A57 Link Roads

**9.72 Addendum to the Statement of
Common Ground with High Peak**

9.72 Addendum to the Statement of Common Ground with High Peak

1.2. Addendum to the Statement of Common Ground with High Peak Borough Council

Appendix A. Extract of Air Quality compliance figure

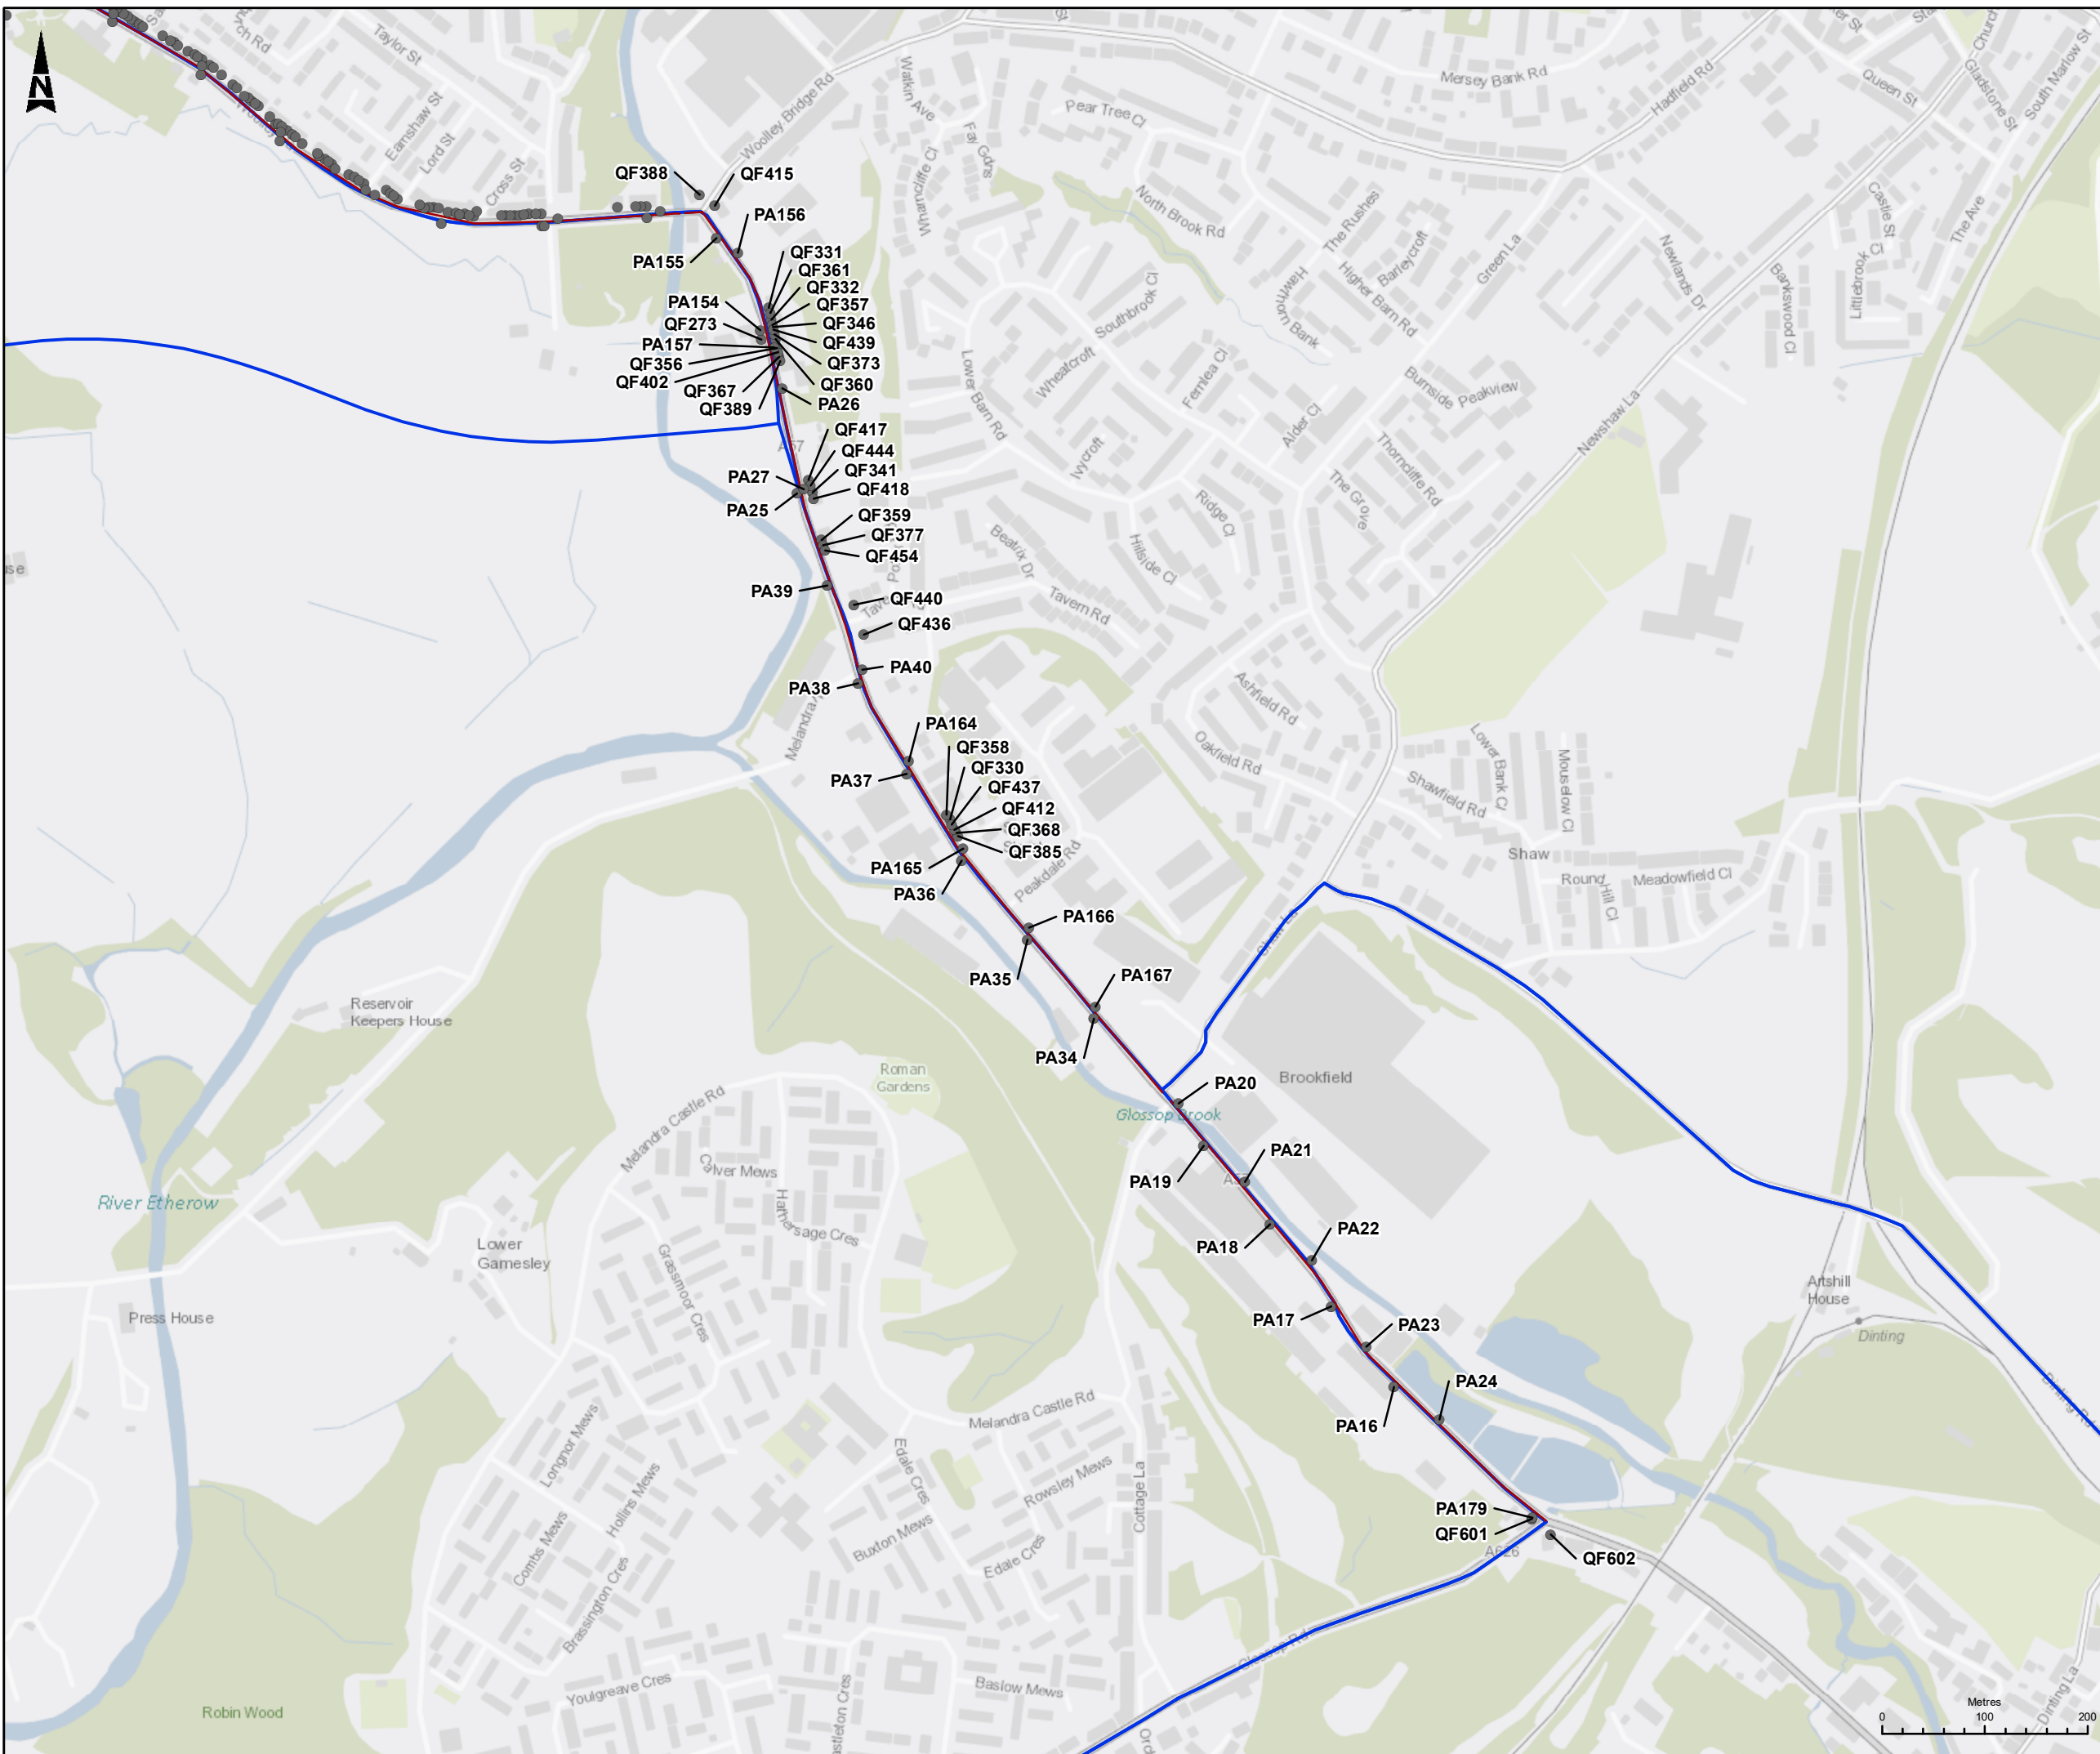
Figure 5.4 Air Quality Compliance Risk Assessment – receptor labels			
<p>Item 8.38 HPBC [REP4-011] asked for the A57 Brookfield qualifying features used in</p>	<p>Given the number of qualifying features and public access receptors included in the compliance assessment it was not</p>	<p>Agreed</p>	<p>Closed</p>

HPBC Item	National Highways Position	HPBC Position	Status
<p>the NO2 compliance assessment to be labelled on ES Figure 5.4 [APP-080].</p>	<p>possible to practically label the qualifying features in ES Figure 5.4 (APP-080) however, an extract of ES Figure 5.4 zoomed in on the A57 Brookfield area with receptor ID labels for qualifying features and public access receptors adjacent to the A57 Brookfield is provided below this table.</p>		
<p>Adjustment of Background Concentrations Data used in Air Quality Assessment</p>			
<p>Item 8.39 HPBC raised concerns about the lack of adjustment to the background concentrations used in the air quality assessment. HPBC [REP4-011] suggest they are concerned about over representation of beneficial effects.</p>	<p>The HPBC query relates to the verification and adjustment of the Department for Environment, Food and Rural Affairs (Defra) mapped background concentrations. National Highways provided a response to question 8.39 in REP3-018. As stated in REP3-018, where the Defra background maps underpredict background monitoring data this could lead to a need to apply a higher adjustment factor in the air quality model verification. The higher the adjustment factor applied, the more conservative the results of the assessment given that the adjustment is applied to both the modelled total concentration with and without the Scheme, which has the</p>	<p>Agreed</p>	<p>Closed</p>
